# Lalmai Footwear Ltd. (Extension)

25 September 2024

## 1. Building information

### Foundation Layout

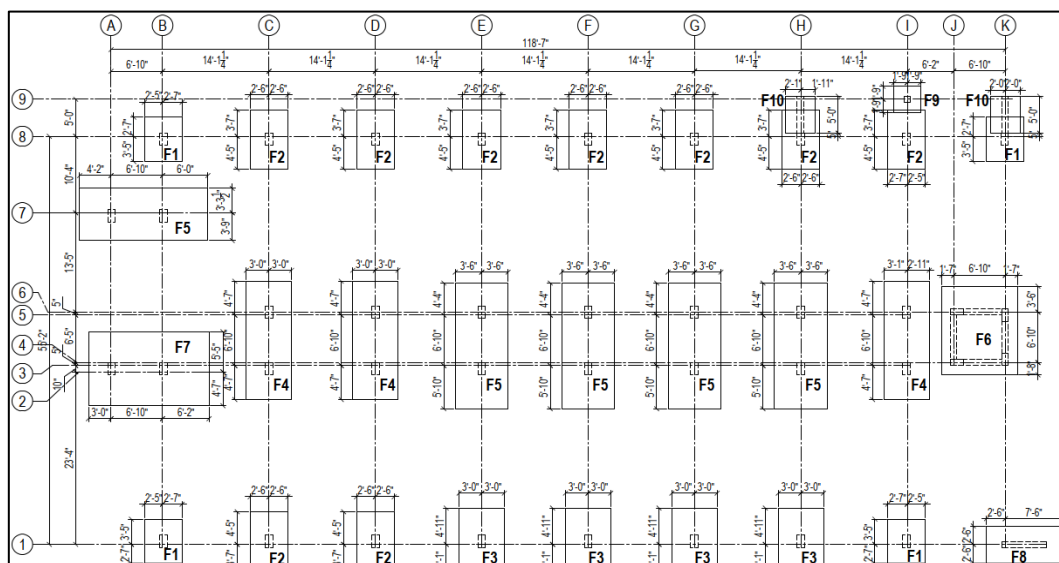
**Description:** Cursory calculation indicates high stress in the foundation (footing) considering the recommended soil bearing capacity in the geotechnical report and footing sizes in the drawing. The building engineer is required to review the adequacy of footings and comply with BNBC based on the soil-bearing capacity.

The geotechnical investigation report consists of 4 borehole data up to a depth of 15m. As per BNBC-2020 table no 6.2.13 requirement a 30 m bore is required to determine the harmonic average SPT "N" value.

| Item No. | Observation                                                                                               | Action Plan                                                                                                                                                                         | Timeline        |
|----------|-----------------------------------------------------------------------------------------------------------|-------------------------------------------------------------------------------------------------------------------------------------------------------------------------------------|-----------------|
| 1.       | High stress in the foundation. (Building 4- Workers' Dining & Resthouse)                                  | Carry out a geotechnical investigation to close the vicinity of the building following BNBC-2020 requirements and determine the accurate soil bearing capacity at foundation depth. | within 6 weeks  |
| 2.       |                                                                                                           | The building engineer is required to review the adequacy of footings as per the updated geotechnical investigation report.                                                          | within 6 weeks  |

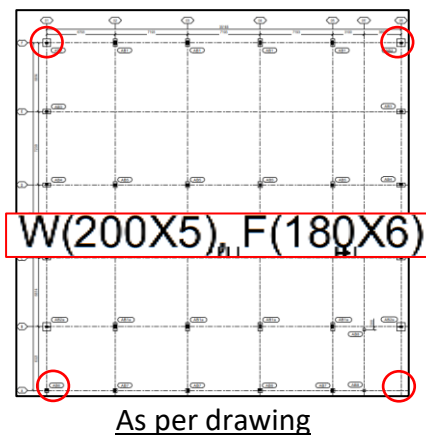
**Description:** In the EA report of the Braiding Shed- Cycle Stand & Shop Shed the response modification co-efficient is considered as IMRF (R=4.5) without any justification/calculation. Also, steel material strength for secondary steel members is considered 345 MPa without any test report. The building engineer is required to update the EA report as per BNBC-2020 requirements based on in-situ material strength and submit it to the RSC for review.

| Item No. | Observation                                                                                               | Action Plan                                                                                                                                                                         | Timeline        |
|----------|-----------------------------------------------------------------------------------------------------------|-------------------------------------------------------------------------------------------------------------------------------------------------------------------------------------|-----------------|
| 6.       | Inconsistencies in Engineering Assessment (EA) report. (Shed 7- Braiding Shed- Cycle Stand & Shop Shed)   | The building engineer is required to update the EA report as per BNBC-2020 requirements based on in-situ material strength and submit it to the RSC for review.                     | within 6 weeks  |

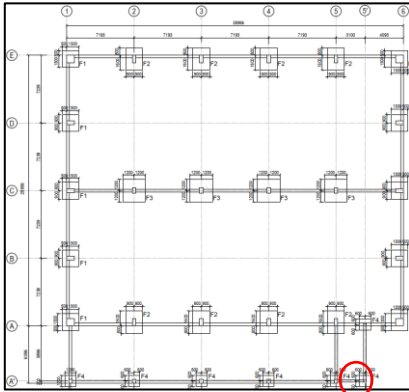
**Description:** During the inspection, a mismatch was found in the as-built drawing. All corner columns were found W-200(5) X F 180 (5) instead of W-200(5) X F 180 (6). The building engineer is required to survey the full structure and update the as-built drawing as per on-site conditions.

| Item No. | Observation                                                                                               | Action Plan                                                                                                                                                                         | Timeline        |
|----------|-----------------------------------------------------------------------------------------------------------|-------------------------------------------------------------------------------------------------------------------------------------------------------------------------------------|-----------------|
| 8.       | Mismatch in the as-built drawing. (Shed 7- Braiding Shed- Cycle Stand & Shop Shed).                       | The building engineer is required to survey the full structure and update the as-built drawing with connection details.                                                             | within 6 weeks  |

Onsite condition

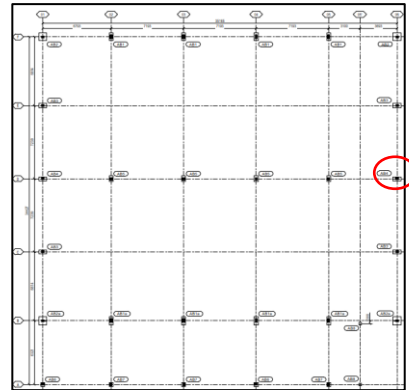
**Description:** During the inspection, a damaged steel column was identified. The building engineer is required to investigate the condition and repair with a suitable method.

| Item No. | Observation                                                                                               | Action Plan                                                                                                                                                                         | Timeline        |
|----------|-----------------------------------------------------------------------------------------------------------|-------------------------------------------------------------------------------------------------------------------------------------------------------------------------------------|-----------------|
| 11.      | Damage to steel column. (Shed 7- Braiding Shed- Cycle Stand & Shop Shed).                                 | The building engineer is required to investigate the condition and repair with a suitable method.                                                                                   | within 6 weeks  |

Wastage Goods Stack Area

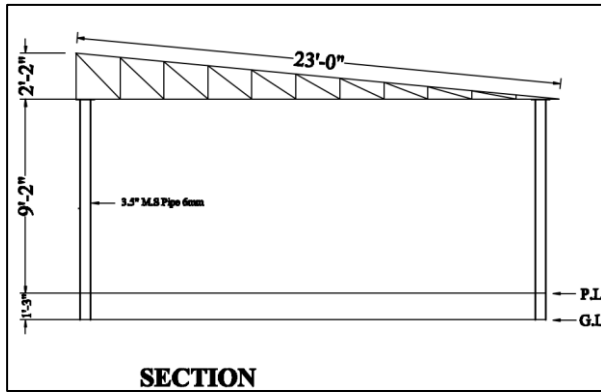
**Description:** A set of drawings was found on site, but the column size of the truss details was missing in the structural drawing. The building engineer is required to survey the full structure and update the as-built drawings with foundation & connection details.

| 14. | Incomplete structural drawing. (Shed 14- Wastage Goods Stack Area)                                                                       | The building engineer is required to prepare an accurate as-built drawing with connection details.                                                                               | within 6 weeks  |
